ADDENDUM

PROJECT: Forestside Estates
Attmar & Palleschi Drive
Brampton, Ontario

PROJECT NO.: 18-017

ADDENDUM NO. E-4

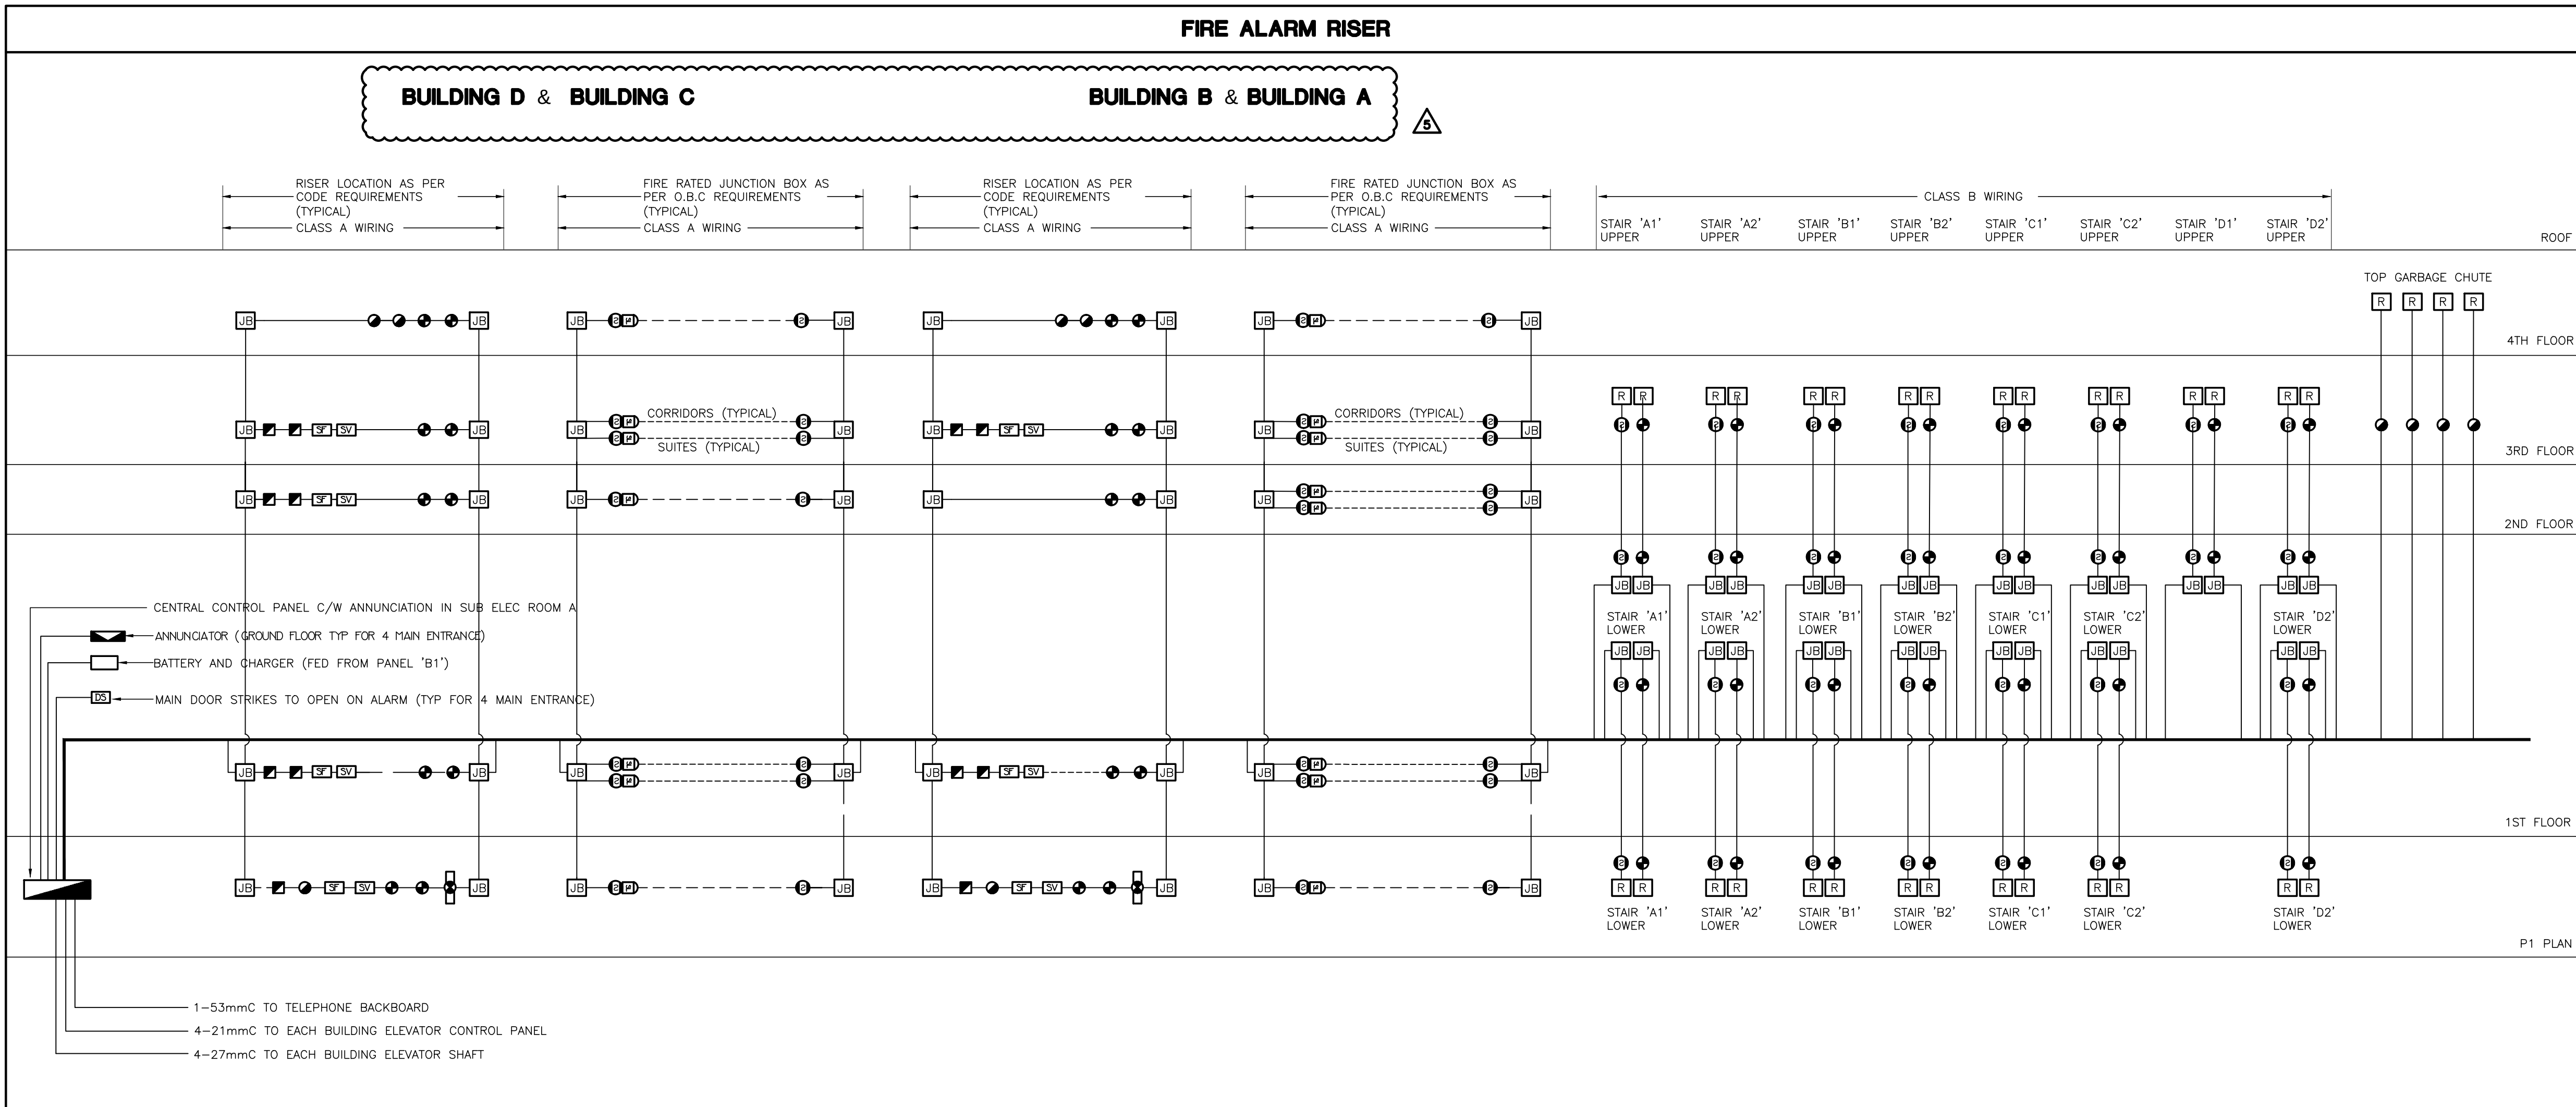
5.1 Revise: Fire alarm schedule as shown.
